Access Compliance Report Public Rights-of-Way (Curb Ramps)

Main Street: CIMA_DR Cross Street: N/A Location: W

ADA ID: RPAT220125111012 Ramp Type: Type 1 - Perpendicular Initial Pass/Fail: Pass Overall Compliance: No Severity Score: 5

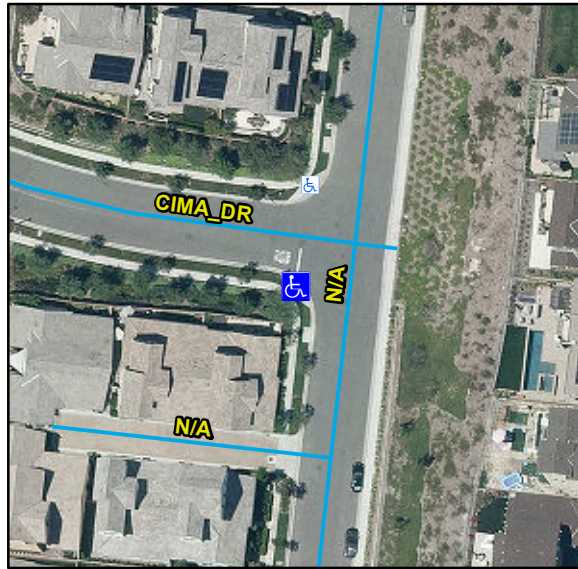
R304.2.2, R304.2.1, R302.7, R304.5.4, R304.5.3, STD 1115

Compliance	Description	Data	Compliance	Description	Data
N/A	Ramp Length (in)	71	N/A	Flare Type LT	
Yes	Ramp Width (in)	86			Sloped
Yes	Ramp Run Slope (%)	7.2	N/A	Flare Slope LT (%)	3.6
Yes	Ramp Cross Slope (%)	0.2	N/A	Flare Traversable LT	No
N/A	Landing Present	Yes	N/A	Flare Type RT	
N/A	Landing Length (in)	48			Sloped
Yes	Landing Width (in)	86	N/A	Flare Slope RT (%)	1.4
Yes	Landing Run Slope (%)	0.6	N/A	Flare Traversable RT	No
Yes	Landing Cross Slope (%)	0.7	Yes	DWS Provided	Yes
N/A	Landing Movement Obstructed?	Yes	Yes	DWS Contrast	Yes
	Landing Movement Type	Bushes	Yes	DWS Length (in)	36
N/A	Landing Shared	No	Yes	DWS Full Width	Yes
N/A	Clear Space	N/A	Yes	DWS Offset Left (in)	0
N/A	Clear Space To Crosswalk (in)	N/A	Yes	DWS Offset Right (in)	N/A
N/A	Marked Crosswalk 1	No	N/A	Marked Crosswalk 2	N/A
	Crossing 1 Direction	NE		Crossing 2 Direction	N/A
	Marked Crosswalk 1 Width (in)	N/A		Marked Crosswalk 2 Width (in)	N/A

N/A	Ramp Inside Crosswalk 1	N/A	Yes	Ramp Inside Crosswalk 2	N/A
	Crossing 1 Slope (%)	0.2		Crossing 2 Slope (%)	N/A
	Crossing 1 Cross Slope (%)	1.4		Crossing 2 Cross Slope (%)	N/A
No	Gutter Ponding	Yes	No	Curb Slope	9
Yes	Gutter Lip Height (in)	0		Road Run Slope (%)	N/A
No	Gutter Run Slope (%)	6.8		Road Cross Slope (%)	N/A
No	Gutter Cross Slope (%)	2.7			
Yes	Overall Surface Condition: Acceptable		Yes	Perp Joint Present	Yes
	Cross Gutter Present?	No		Spandrel Present?	No
	Replace Cross Gutter?	N/A		Replace Spandrel?	N/A

Remove & Replace Entire Ramp. Remove & Replace Gutter.
